**O & M INSPECTION REPORT
FOR NAVIGATION AND SHORE PROTECTION PROJECTS**

1. Project Name: Honokahau SBH
2. Date of Inspection: 8 May 2002
3. Inspection Personnel:

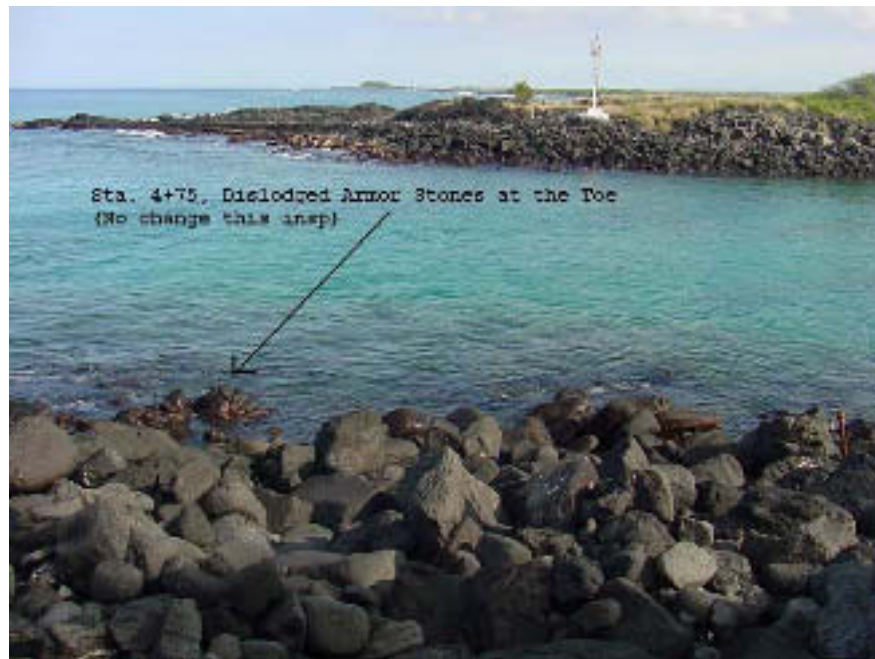
b. Sta. 5+75; Sta. 5+20 and Sta. 4+90, armor stones have been pushed up by wave action, this causes a 2' mound and associated 2' depression in the sideslope.

c. Sta. 4+75, armor stones are dislodged at the toe and have caused a void at the waterline.
